– Shifting of Bebeedukekkan—
Estimate for Rs 3r,000/- for construction of
sanctions quarters — Mysore city – Municipality

Sheffield of Bedroom Accommodation at Mysore

TYPE DESIGN OF SWEEPERS QUARTERS

MARAGONDANA HALLI MANDI MOHALLA MYSORE

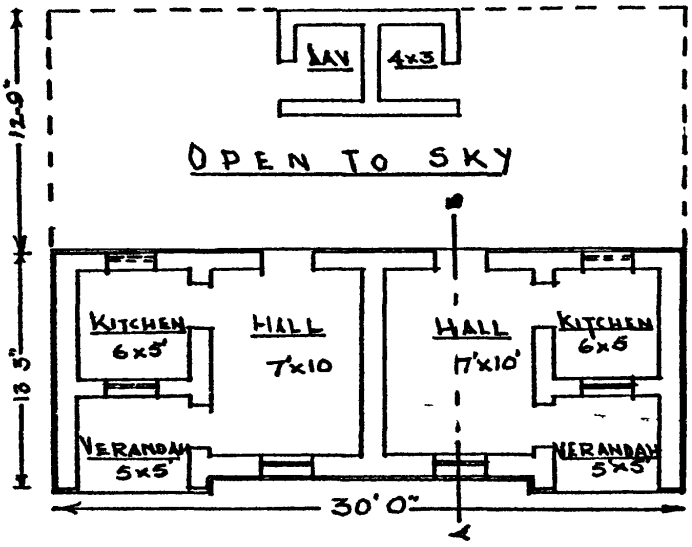
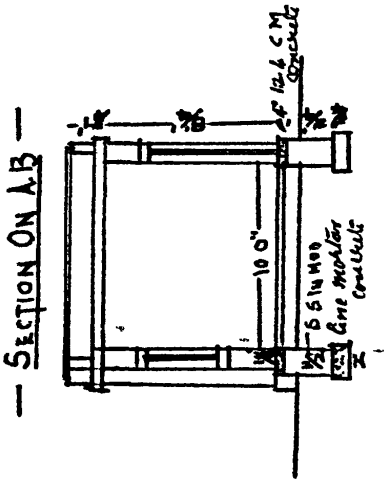
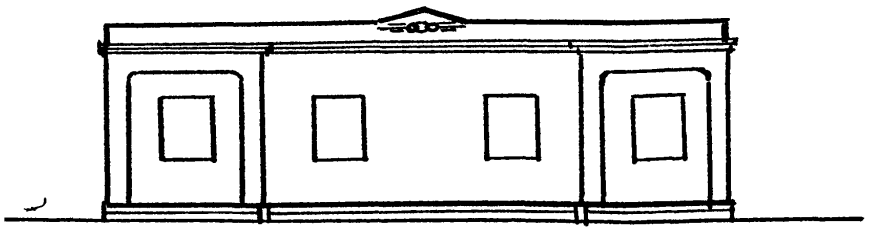
13) The estimate for constructing 32 Sweepers Quarters at Mandi-Mohalla, Mysore is scrutinized for Rs 70,000/- subject to the following observations -

14) Burnt brick in lime mortar may be constructed for jambs of doors and windows to prevent damages to doors and windows by white ants

15) 2 The top two courses of the superstructure may be constructed out of burnt brick in lime mortar below the R C C joists of the brick nogged roof

TYPE DESIGN OF SWEEPERS QUARTERS

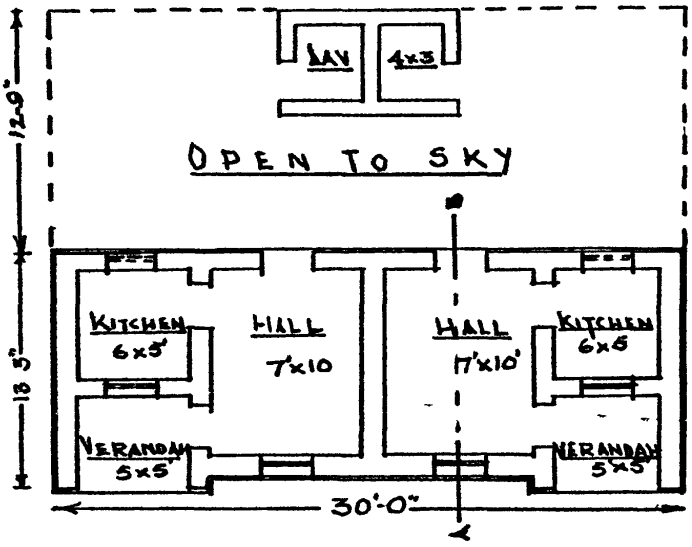
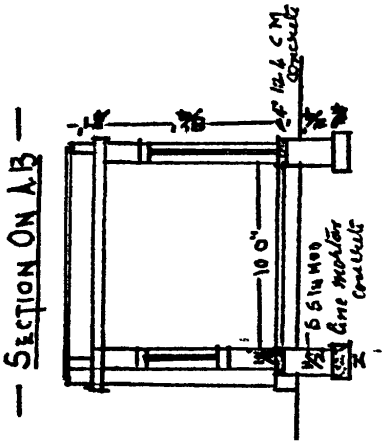
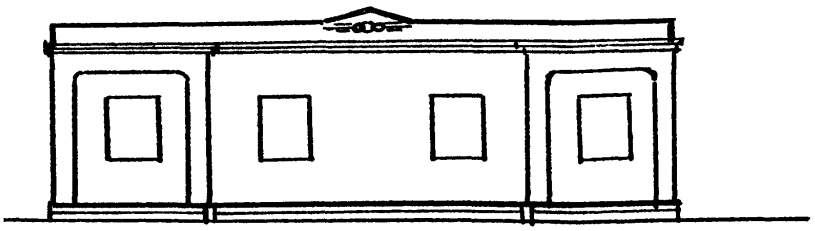
Net plastering					~~1891~~ 20-95 Or Say	~~Sqrs~~ 21	6 - -	~~126~~ - -	
White washing & colour 2 Coats as per above plastering		-	-			~~Sqrs~~ 21	0 8 -	~~11~~ - -	
Painting with Chocolate Painting 2 Coats to Doors & windows mixed and applied as per Bombay Specifications		This item is disallowed as the rate provided for doors and windows are inclusive of painting with 2 coats with approved paint							Rate 15/5/53
Doors	2¼×6	2½	-	6½	408				
Windows	2¼×4	2½	-	3½	79				
					487 Or say	550 sqrs	1 - -	33 - -
